ITEM 10. DEVELOPMENT APPLICATION: 245-247 RILEY STREET SURRY HILLS

FILE NO: D/2008/1505

Proposal Summary: Consolidate the two existing dwellings on Riley Street to a single dwelling, including alterations and additions. Demolition of the existing garage and roller door facing Little Riley Street and the construction of a four storey dwelling and pool. It is also proposed to subdivide the site.

Figure 7: Cross section of the proposed development as viewed from the south

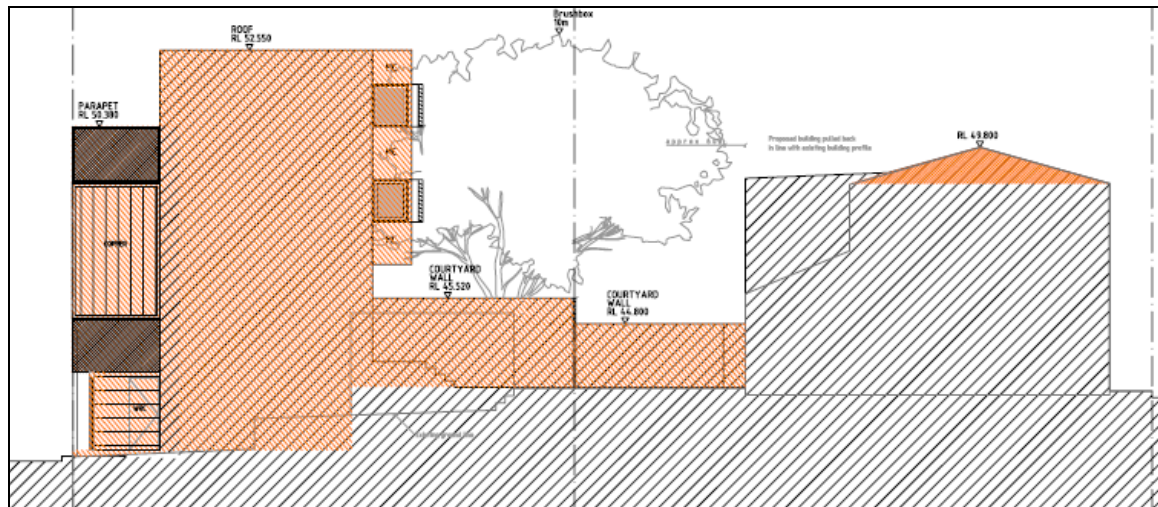
- (a) The proposal does not comply with the 135m² minimum site area requirement of Part F, Section 1.1, with 124.7m² and 108.2m² proposed.
 - (b) The proposal does not comply with the minimum separation distance of 12m between the new and the existing dwelling required by Part G, Section 2.2, with 9.4m proposed, resulting in adverse privacy effects.

- (e) The proposed rear dwelling does not meet the requirements of Part G, Section 2.5, which provides a maximum height limit of 5.4m.
- (3) The application due to the proposed design, bulk, form and scale is contrary to Clause 10 of the *Heritage Development Control Plan 2006*, which requires development on rear lanes to be subsidiary than the development fronting the main street.

Matter to be Considered	Compliance	Comment
PART G: SPECIAL PRECINCTS		
Residential Development on Rear Lanes Section 2 to 2.7	*	<p>Does not comply The proposed dwelling only provides for a 9.4m separation distance from the existing dwellings. This distance is inadequate and result in adverse privacy effects between the two dwellings habitable rooms and open space.</p> <p>In addition, the new dwelling exceeds the maximum length of 7m, is not setback 1.2m from the rear lane and exceeds the maximum height of 5.4m, which results in adverse amenity effects to the adjacent residential building to the south.</p>

29. The proposed dwelling to be located on Little Riley Street is much larger than the existing dwellings on Riley Street. It is considered that the proposed dwelling will dominate the streetscape of Little Riley and Goodchap Streets and fails to respect the character of the surrounding area. It provides an inappropriate transition to the adjacent building to the south and those two storey terraces that line Goodchap Street. In addition, it will be visually prominent as it terminates the view line of Goodchap Street.

39. The proposal is considered to result in substandard accommodation for both dwellings, with the two dwellings to be located 9.4m from each other, which is contrary to Clause 2.4 of the South Sydney DCP 1998, which seeks a distance of 12m between opposite habitable rooms.

40. The proposed dwelling does not provide a side setback from the southern boundary and will therefore obstruct the north facing habitable room windows of 16a Little Riley Street, restricting light and ventilation to these rooms, resulting in substandard accommodation. While it is noted there is no easement on the Title to protect these windows, Part G, Sections 2.1 and 2.5 of the South Sydney DCP 1998 provide for a maximum height of 5.4m and a depth of 7m for buildings on rear lanes, of which the proposal exceeds both.
